The following error was found in the EX ROVR Instruction Manual. We apologize for the error and correct it. Please check back for additional details.

List of Corrections

No.1 Error Correction

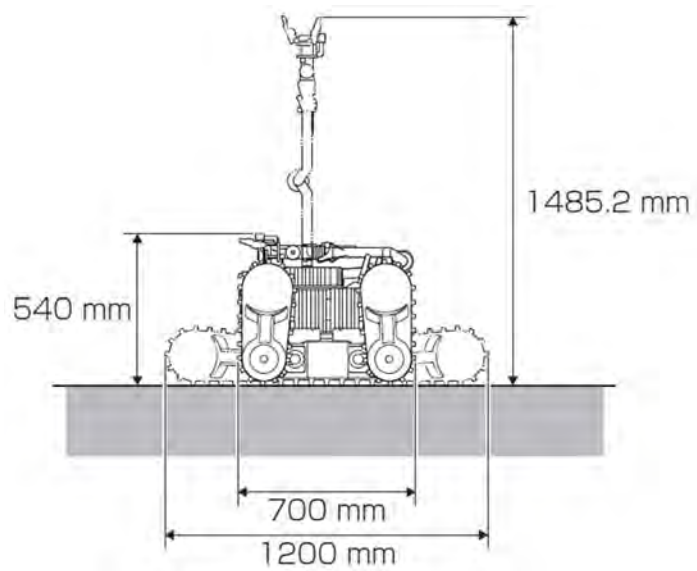
(Incorrect)

A: Slope that can be navigated during automatic patrol

Ramps: Up to 1 m high

Slope: Up to 15°

(Correct)

A : Slope that can be navigated during automatic patrol

Slope: up to 30 degrees in the frontal direction (There shall be no slip when running)

No.2 Error Correction

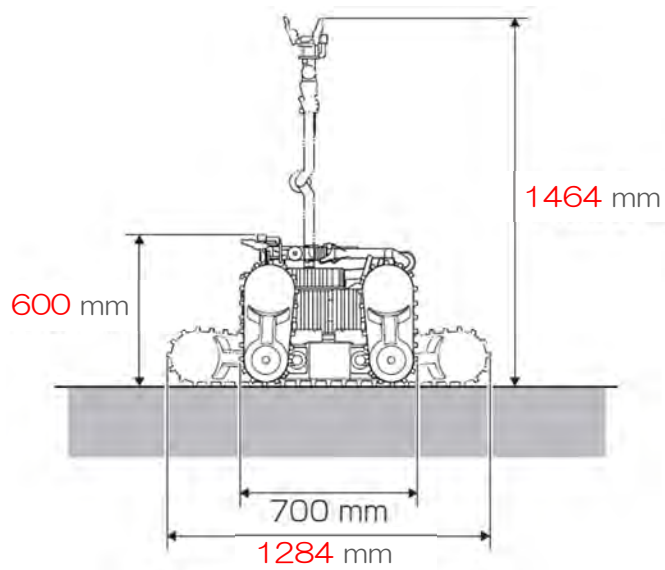
(Incorrect)

(Correct)

No.3 Error Correction

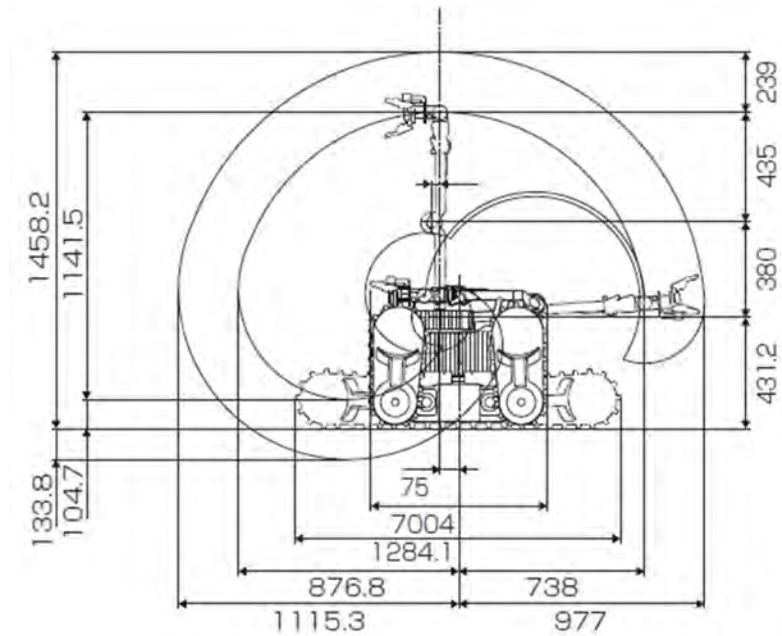
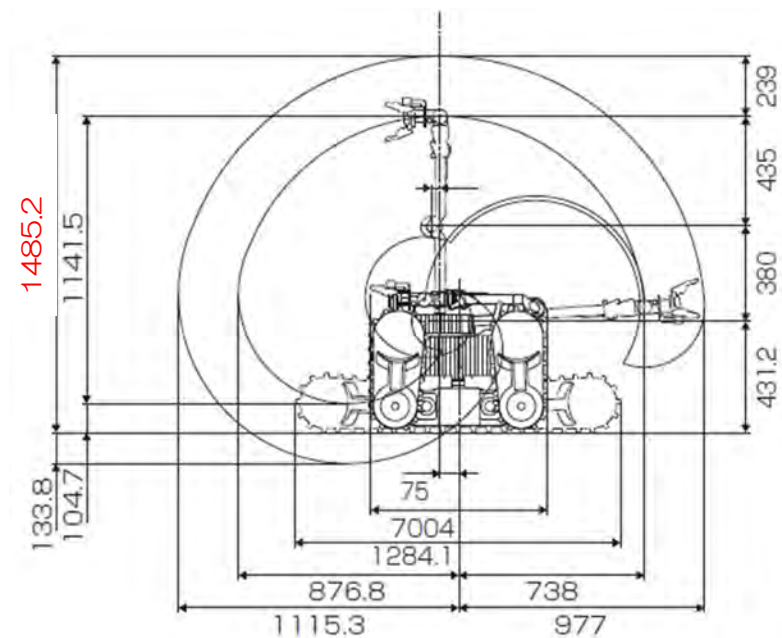
(Incorrect)

(Correct)

No.4 Error Correction

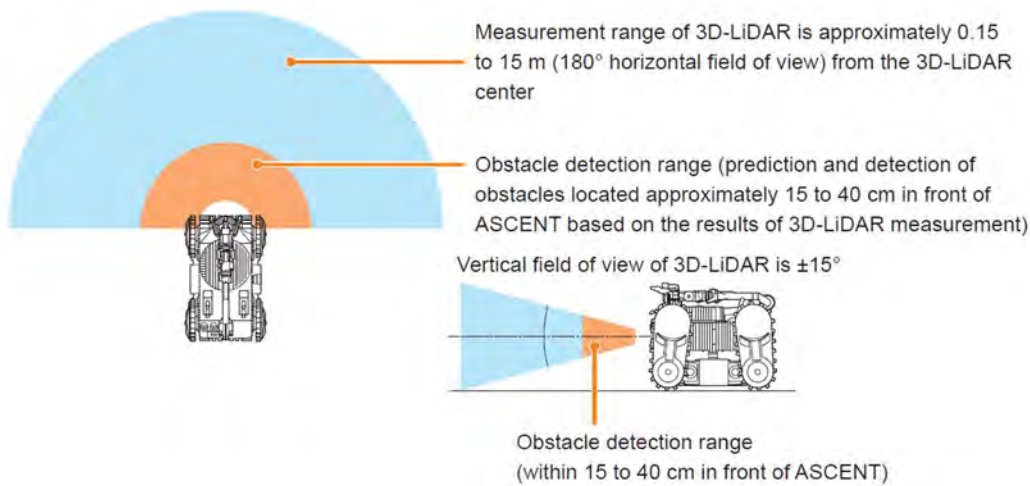
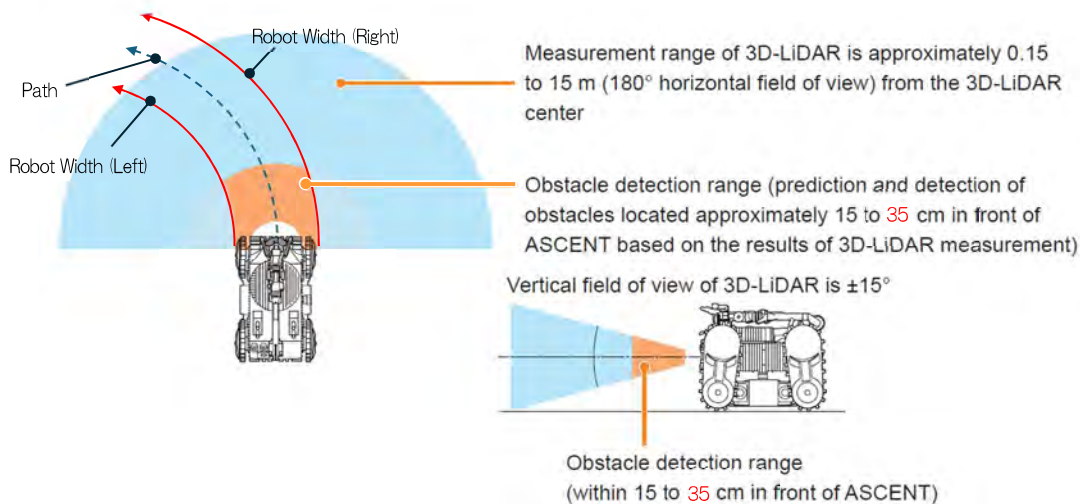
(Incorrect)

ASCENT is equipped with obstacle detection that uses front-mounted 3D-LiDAR. During scenario execution, ASCENT stops immediately when an obstacle is detected. This obstacle detection function is active only during scenario execution, not during teleoperation.

The obstacle detection function, based on 3D-LiDAR data, predicts ASCENT's position one second ahead and stops operation if an obstacle is detected at the predicted position. As shown in the figure below, the detection range is approximately 15 to 40 cm in front of ASCENT.

(Correct)

ASCENT is equipped with obstacle detection that uses front-mounted 3D-LiDAR. During scenario execution, ASCENT stops immediately when an obstacle is detected. This obstacle detection function is active only during scenario execution, not during teleoperation. In addition, the obstacle detection function is not active when the front sub-track is lowered toward the ground (less than 95 degrees) during scenario execution.

The obstacle detection function, based on 3D-LiDAR data, is designed to stop the operation of ASCENT when it detects an obstacle within approximately 15 to 35 cm in front of it, considering the width of the robot along its path.

No.5 Additional Contents

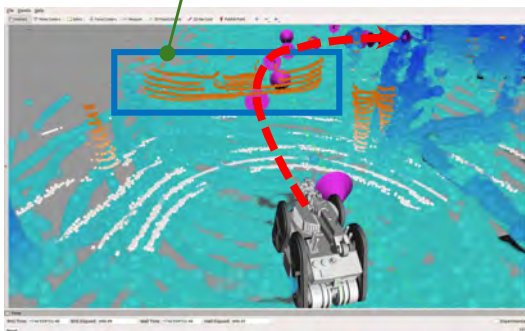
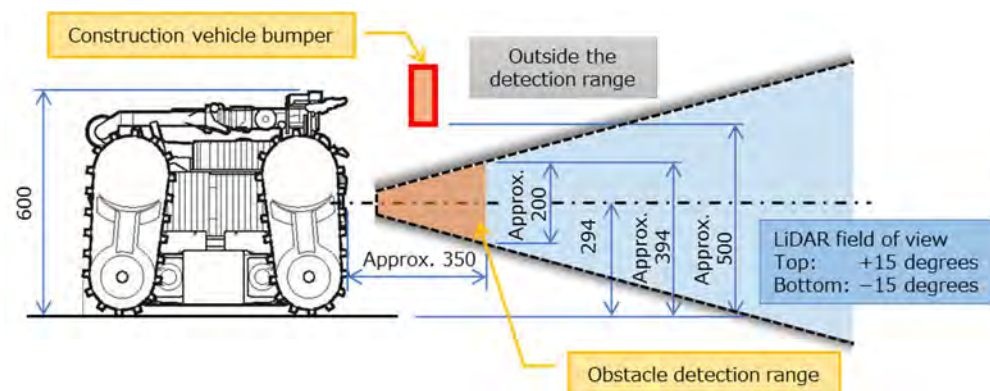
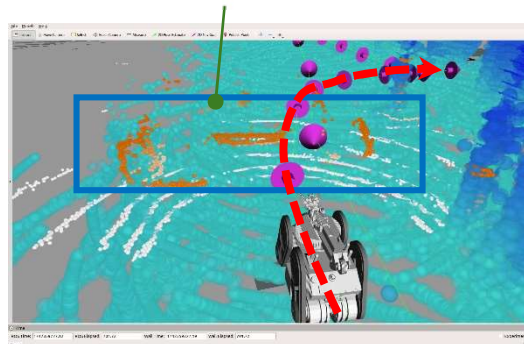
- **Avoid relying exclusively on the obstacle detection function.**

Even if 3D-LiDAR can detect obstacles at a distance, if the robot gets closer and moves out of the detection range, the obstacle detection may fail, and the robot may collide with an obstacle.

As shown in the figure on the left, when a construction vehicle is parked on the route and its bumper is positioned in relation to the robot as depicted in the figure below, the bumper cannot be detected when the robot approaches because it is outside the detection range of the 3D-LiDAR.

No.6 Error Correction

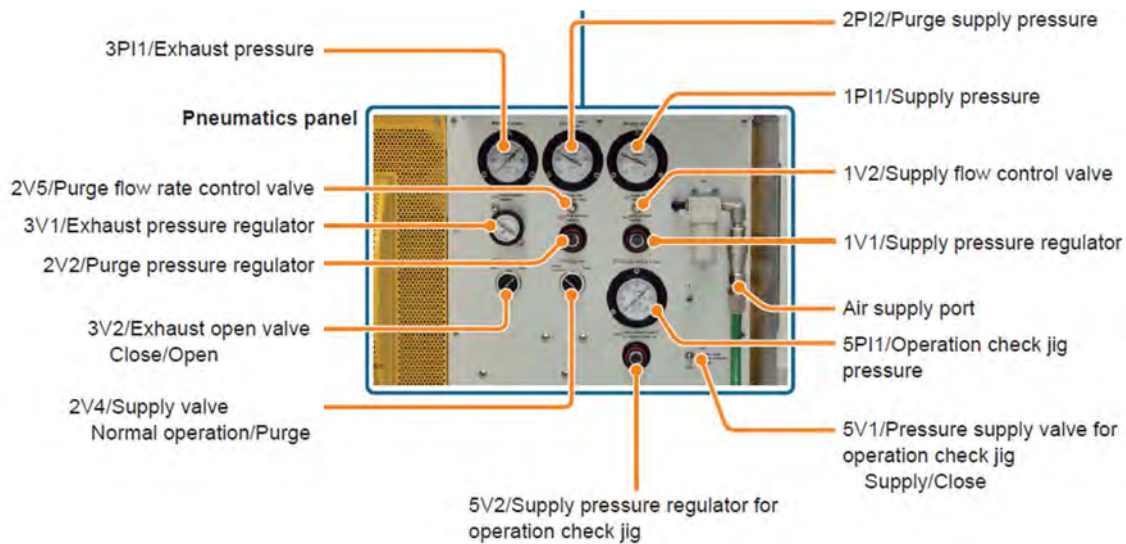
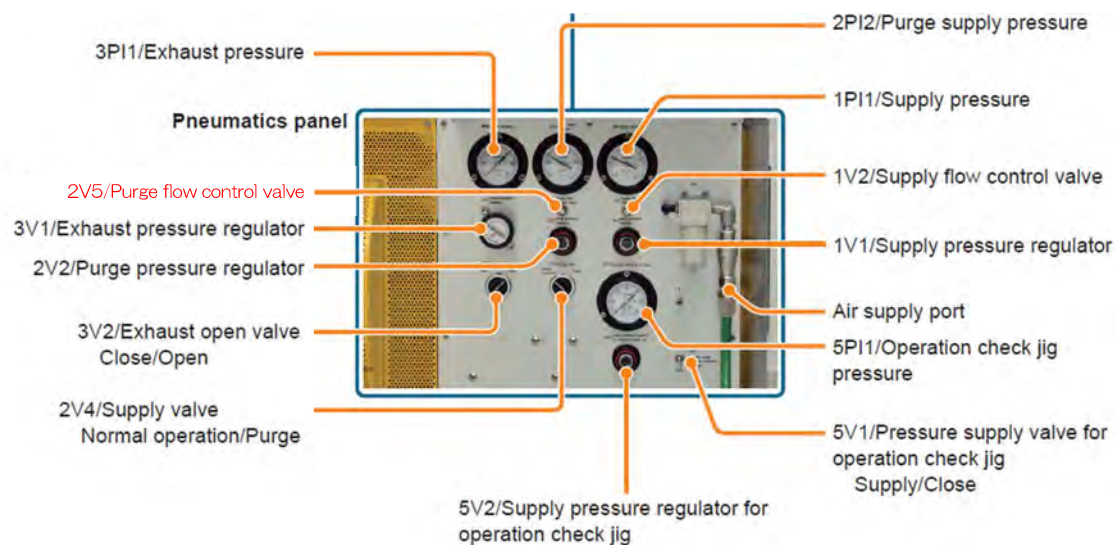
(Incorrect)

(Correct)

No.17 Error Correction

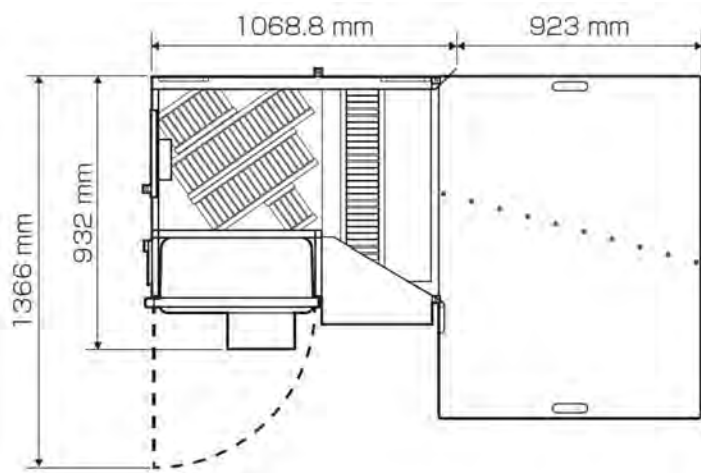
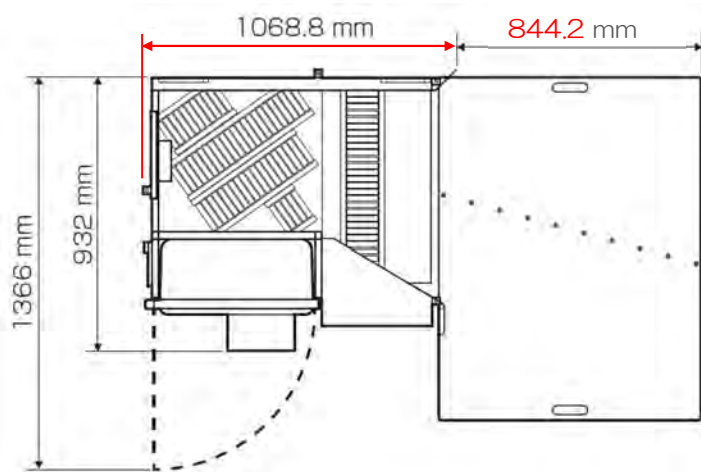
(Incorrect)

(Correct)

No.18 Error Correction

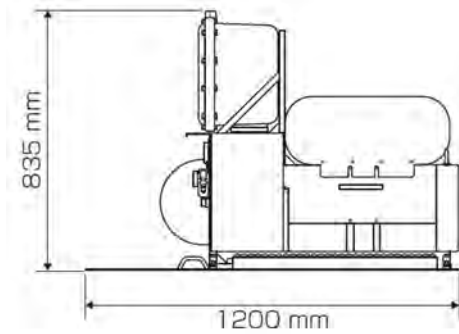
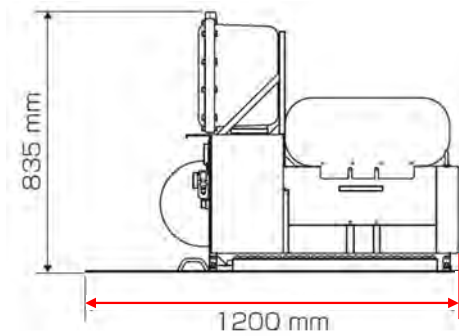
(Incorrect)

(Correct)

No.20 Nameplate update

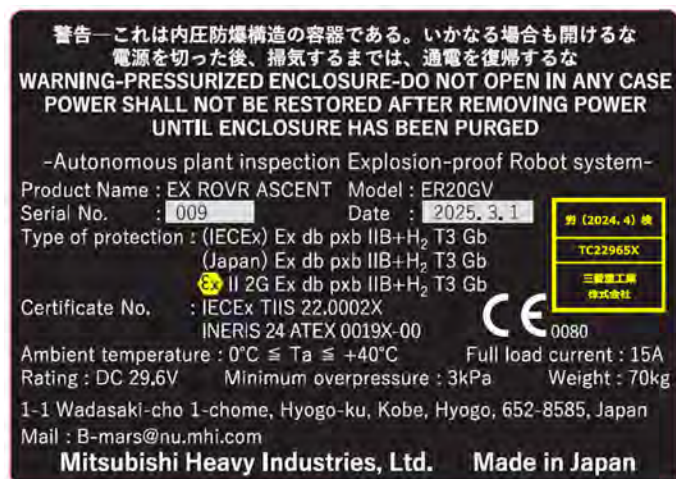
(Pre-update)

(Post-update)

No.21 Nameplate update

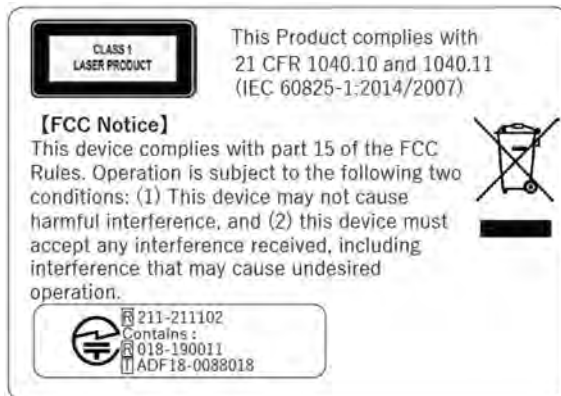
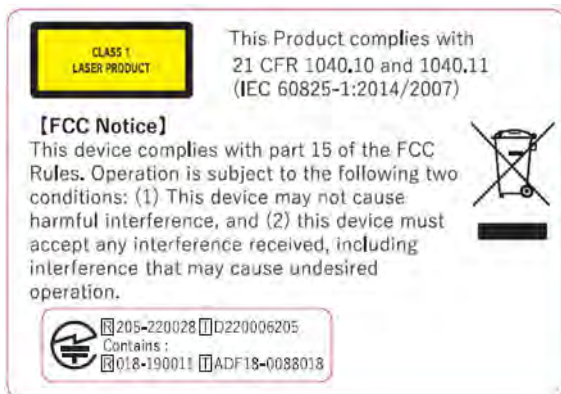
(Pre-update)

(Post-update)

No.22 Nameplate Update

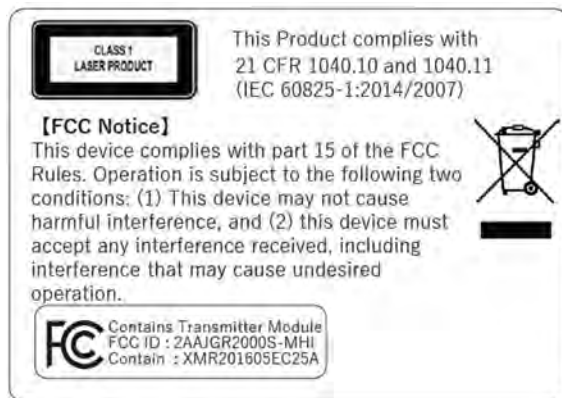
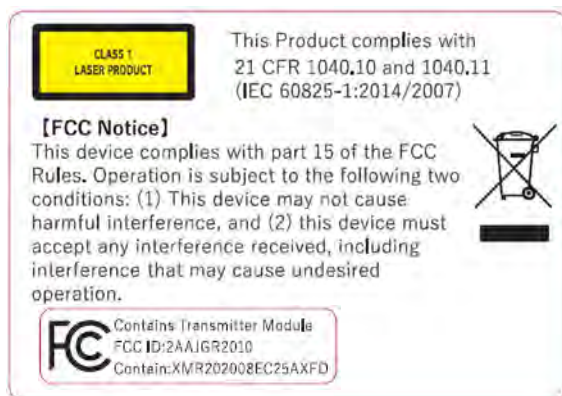
(Pre-update)

(Post-update)

No.23 Nameplate update

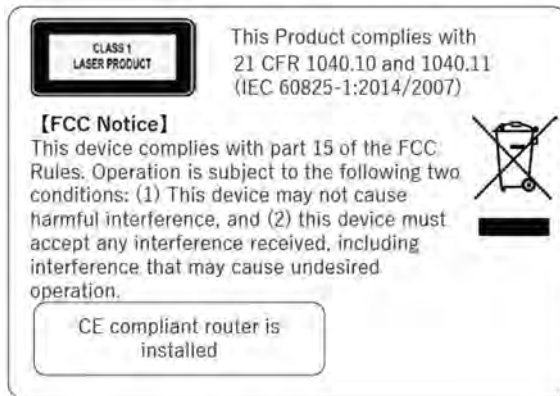
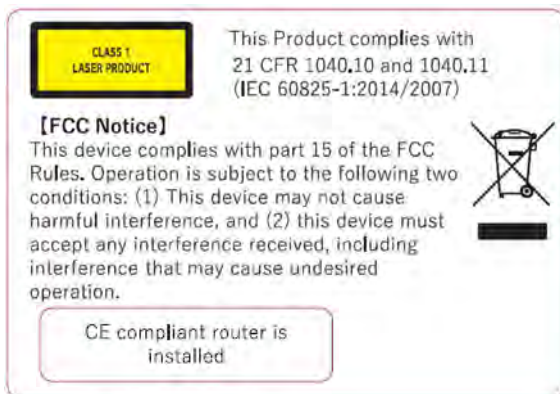
(Pre-update)

(Post-update)

No.24 Nameplate update

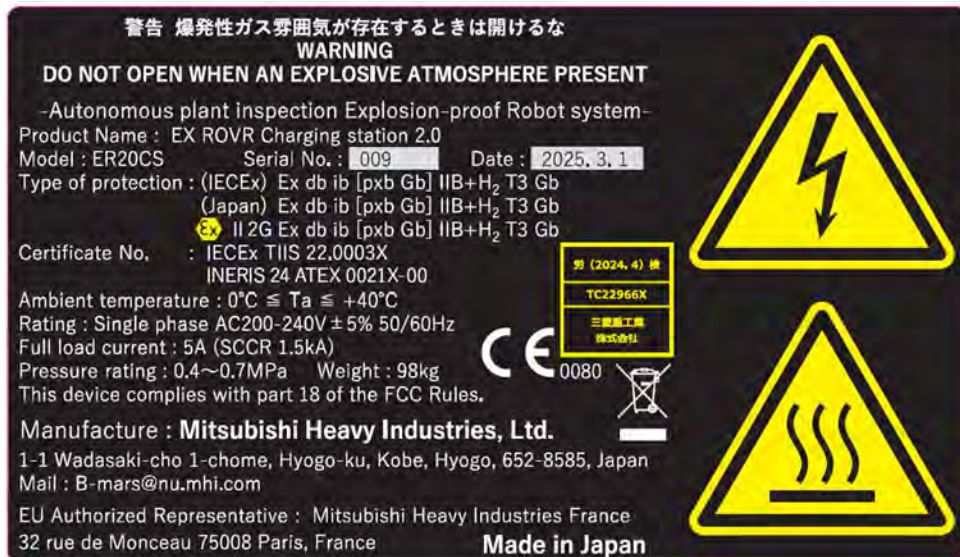
(Pre-update)

(Post-update)

No.26 Nameplate update

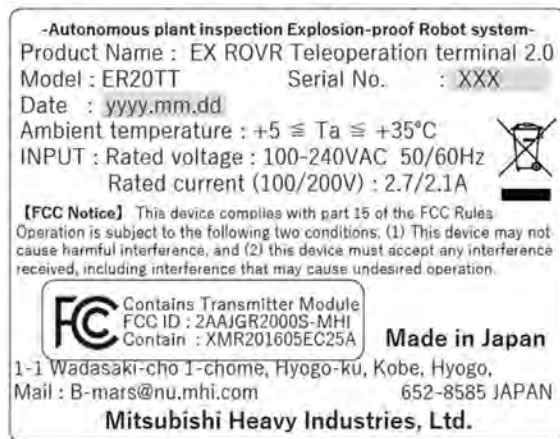
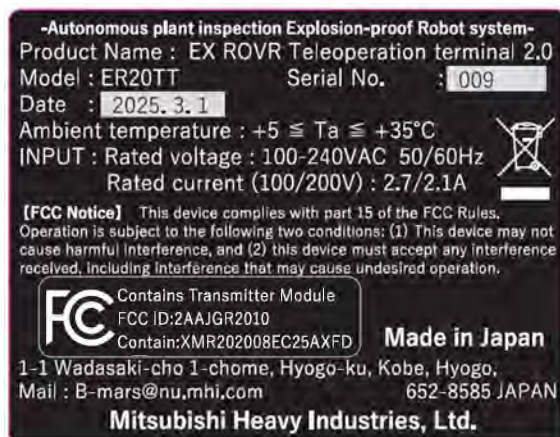
(Pre-update)

(Post-update)

No.27 Nameplate update

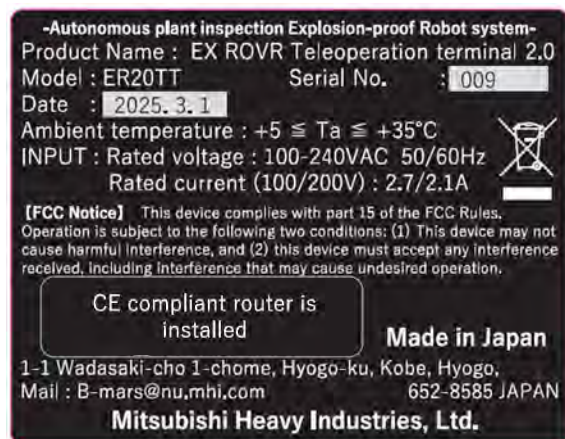
(Pre-update)

(Post-update)

No.29 Additional Content

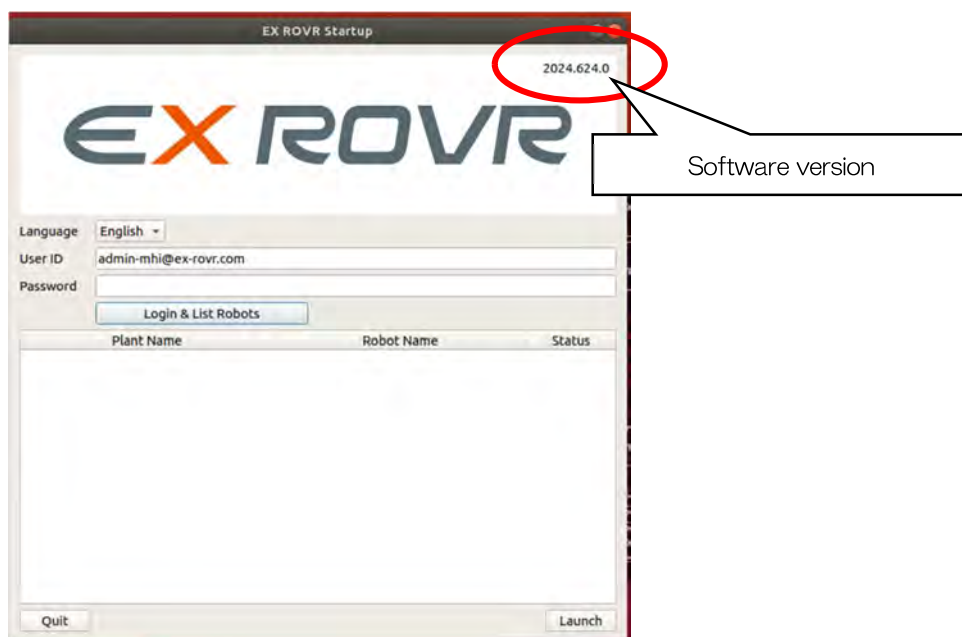
Depending on the site situation, ASCENT operation may need to be stopped immediately, in which case an attendant must press the emergency stop button (or torque off button) on the rear of ASCENT to stop its operation on the spot. **Keep pressing the button until ASCENT operation stops completely.**

No.31 Additional Contents

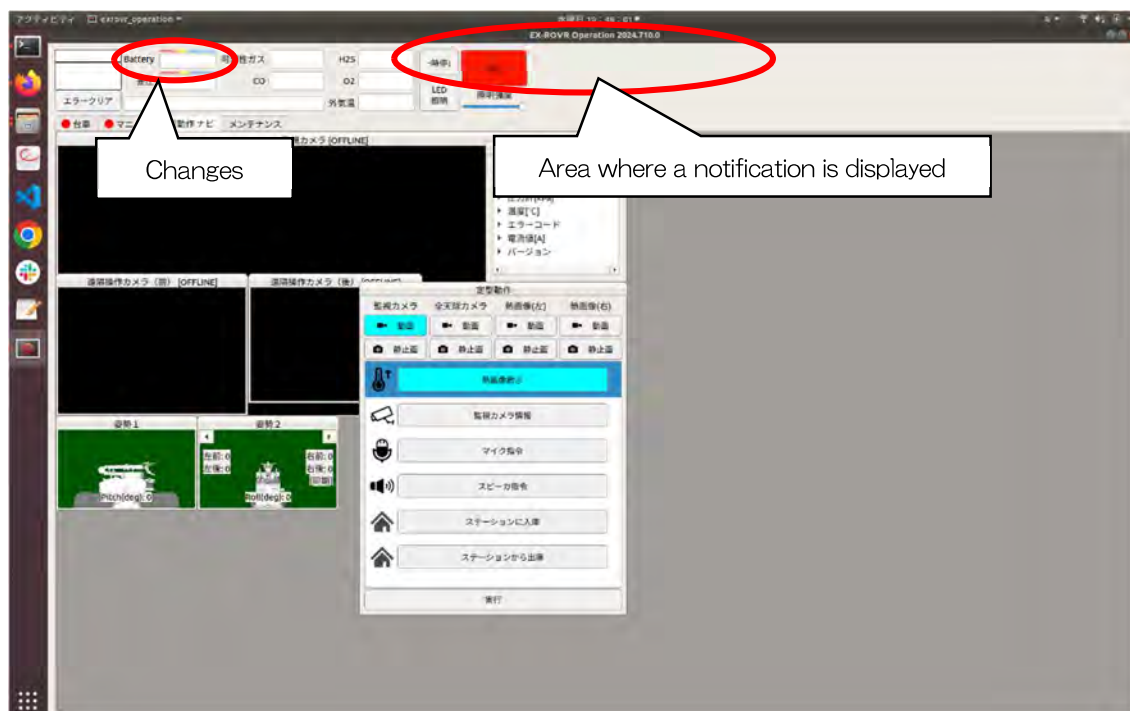
A notification is displayed on the Teleop screen when the battery is low. ASCENT also generates an alarm (warning sound). The judgment value for generation is 26V or less.

When the battery is low, the background of the battery indicator flashes between white and red.

A notification is displayed. The notification disappears when you press [OK].

ASCENT generates an alarm (warning sound). The warning sound disappears when ASCENT enters the Charging Station.
